ACRONYMS AND ABBREVIATIONS

Figure 9.2.1-1 Essential Service Water System Piping and Instrumentation Diagram (Sheet 1 of 3)

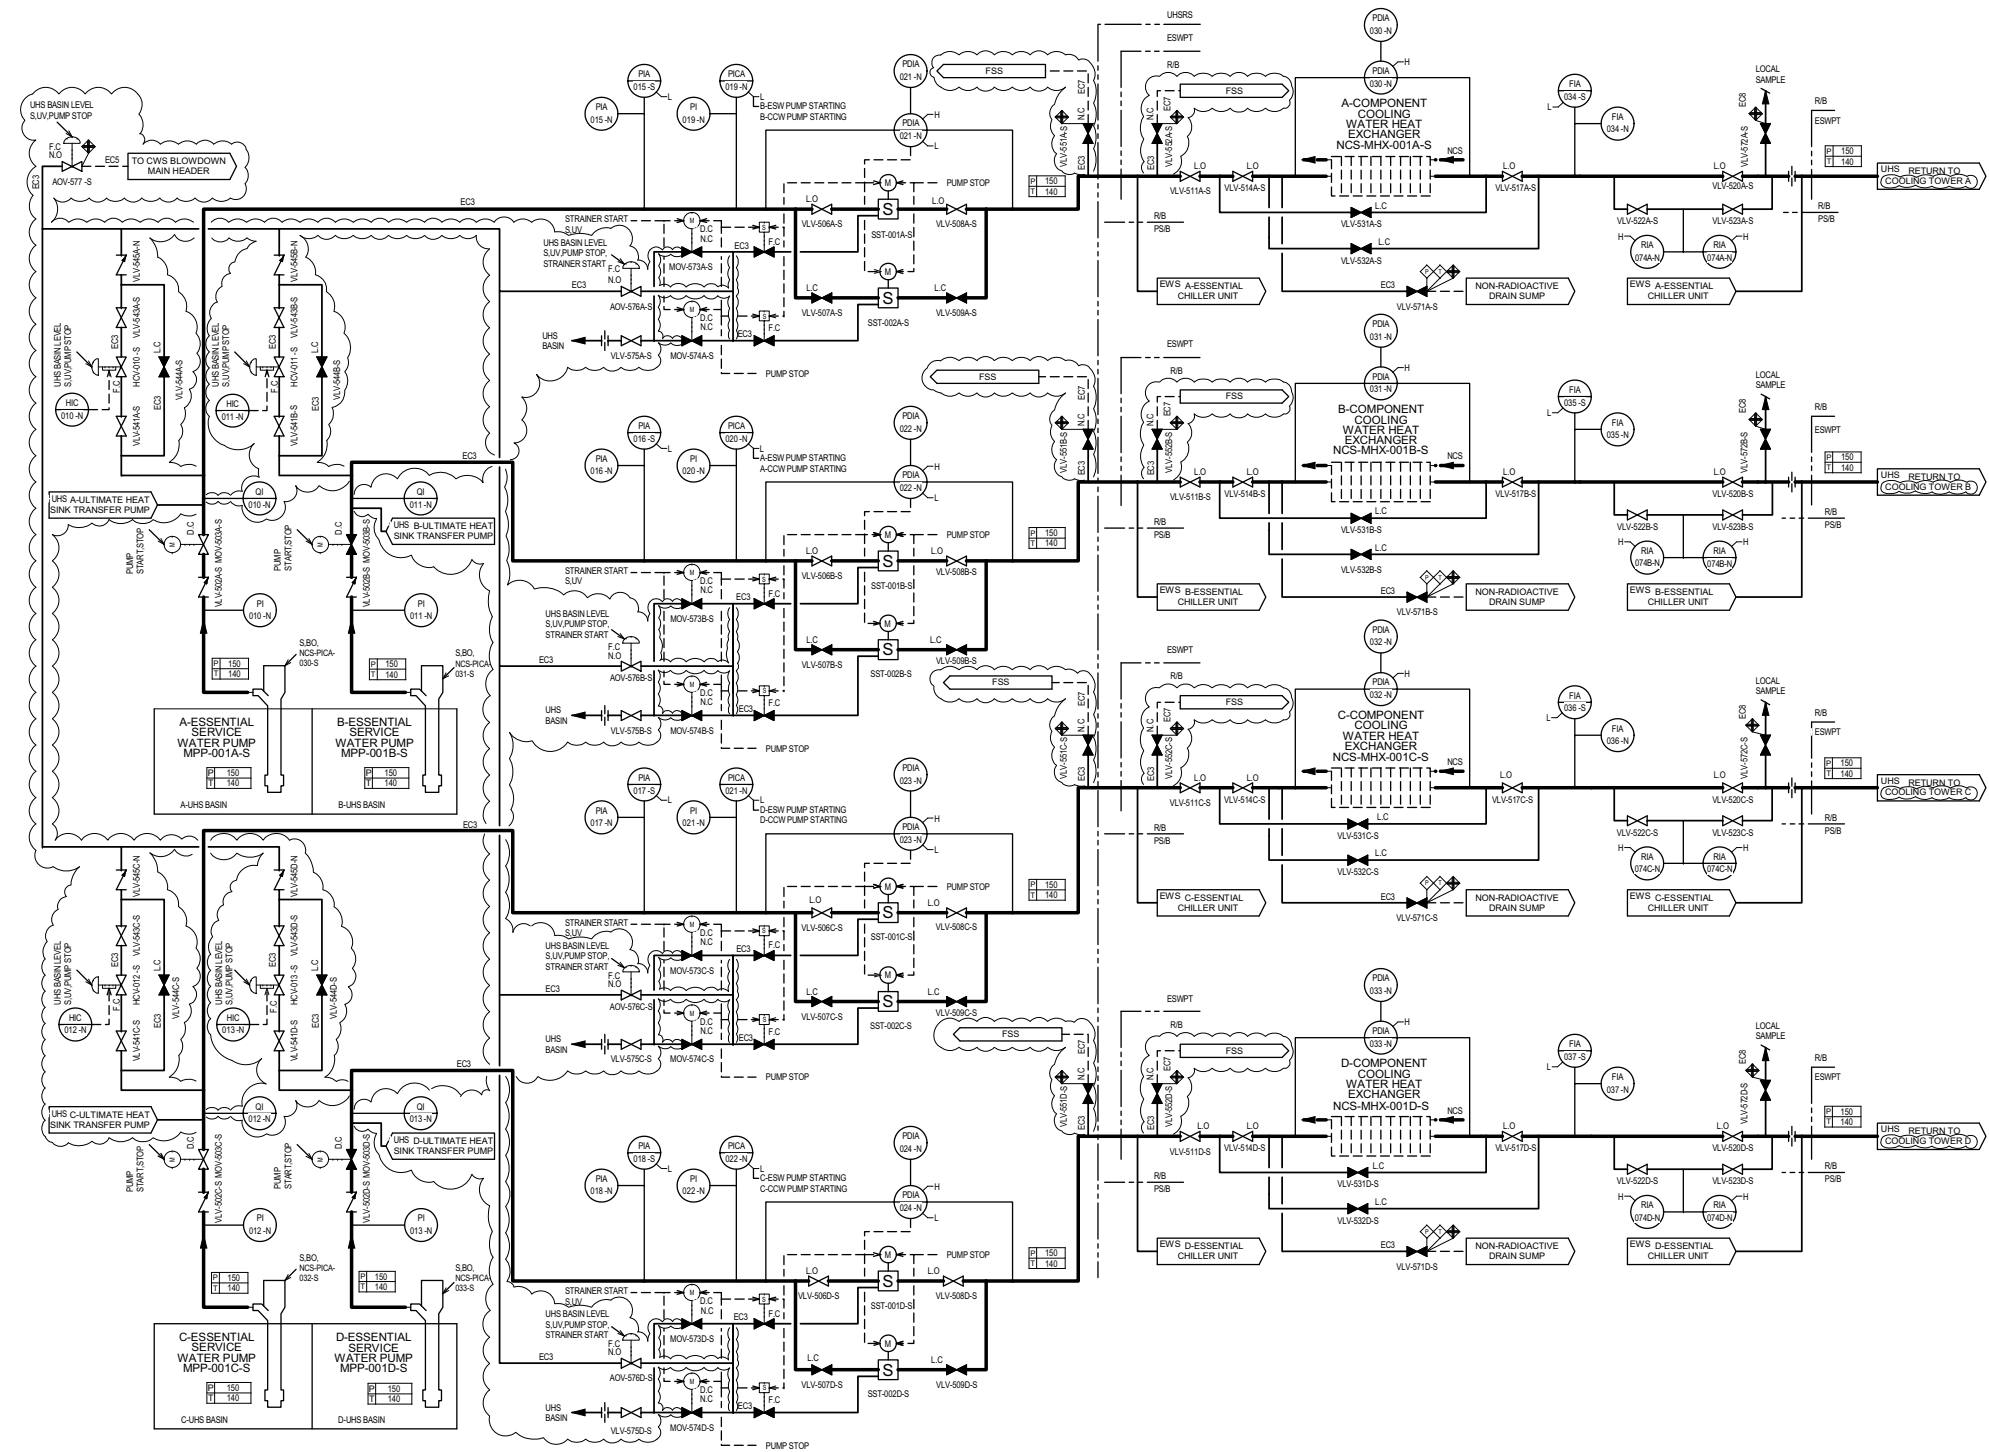
DCD_09.02.
01-40
MIC-03-09-0
0012
